**ADDENDUM NUMBER 2  
BID NUMBER IFB 21-017**

**Summer Roofing Projects 2022**

**ISSUED: December 6, 2021**

**PURCHASING DEPARTMENT  
UNIFIED SCHOOL DISTRICT 500  
2010 N. 59<sup>th</sup> STREET, ROOM 370  
KANSAS CITY, KANSAS 66104  
913-551-3200**

**Argentine Middle School**  
2123 Ruby Avenue, Kansas City, KS 66106

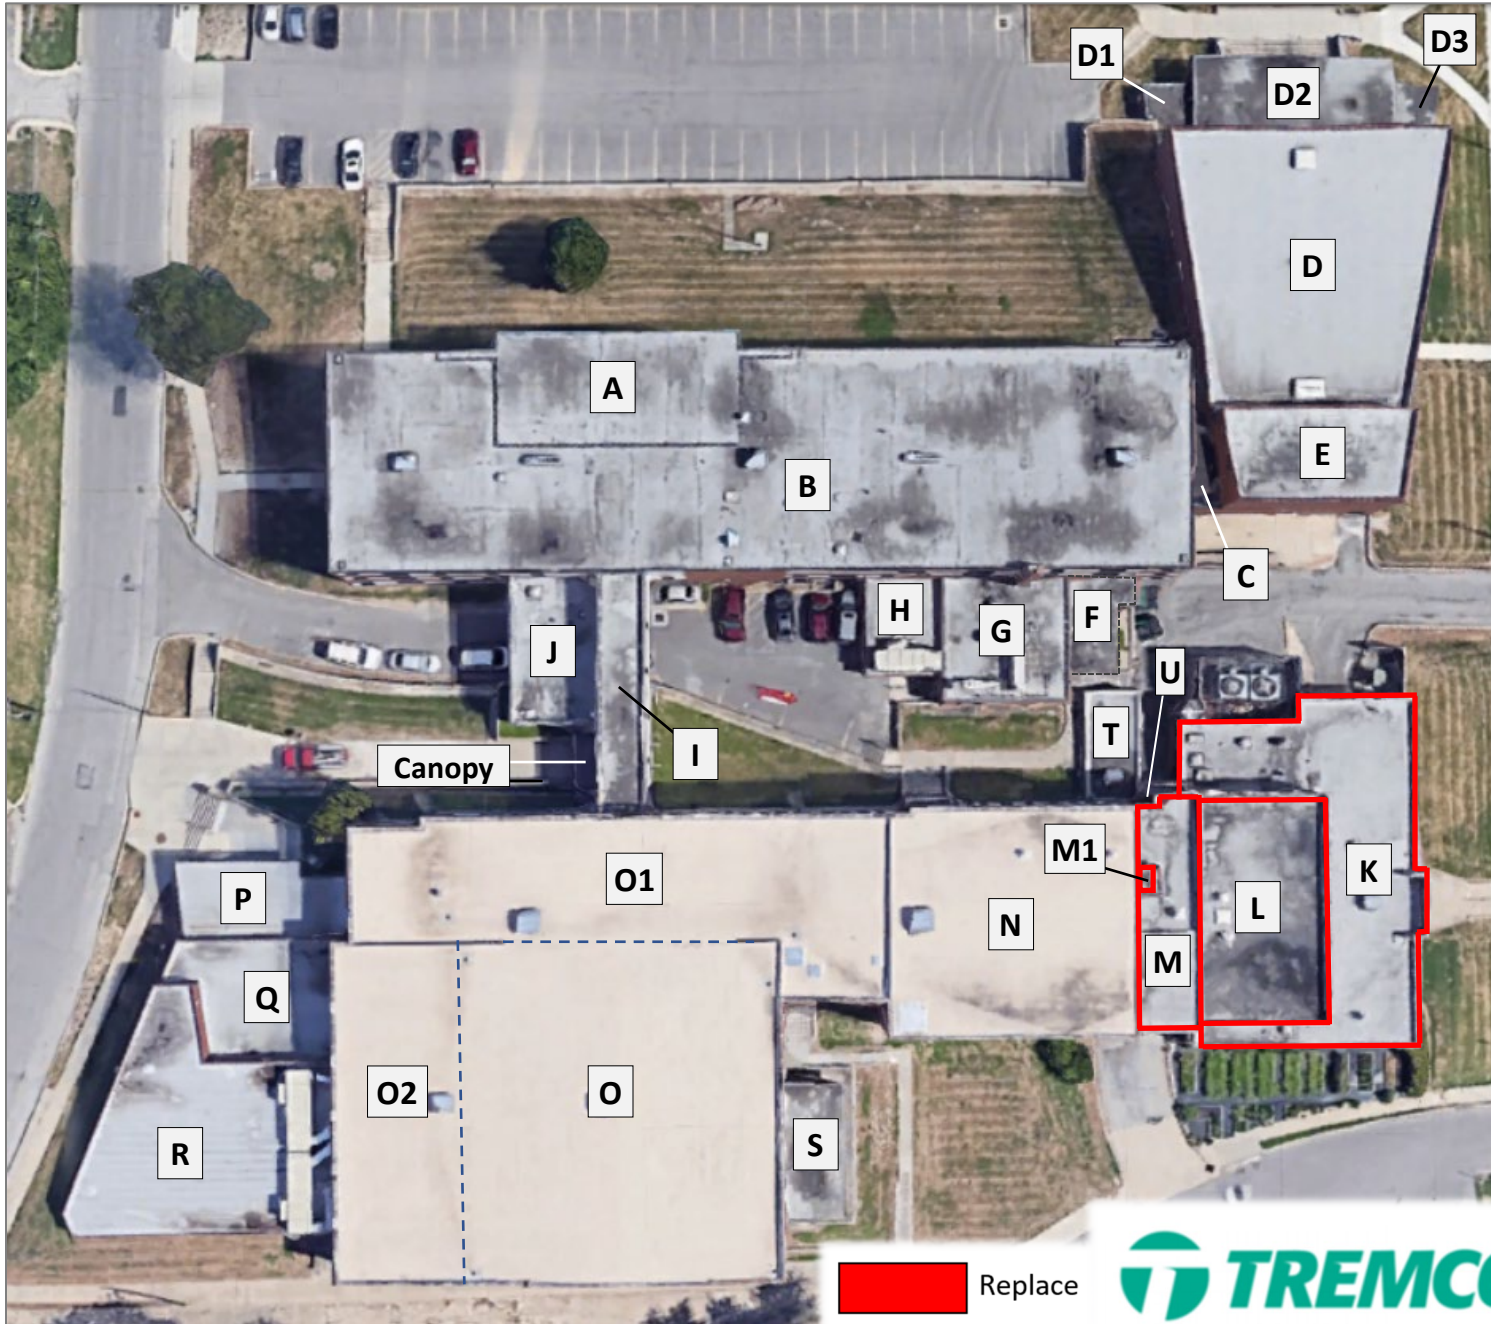
- A. Argentine Middle School
  - 1. Use 24-gauge galvanized metal for all counterflashing including perimeter walls.
  - 2. Add Roof M-1 to base bid. Use same roof replacement scope of work as Roof M. (See attached revised roof plan)
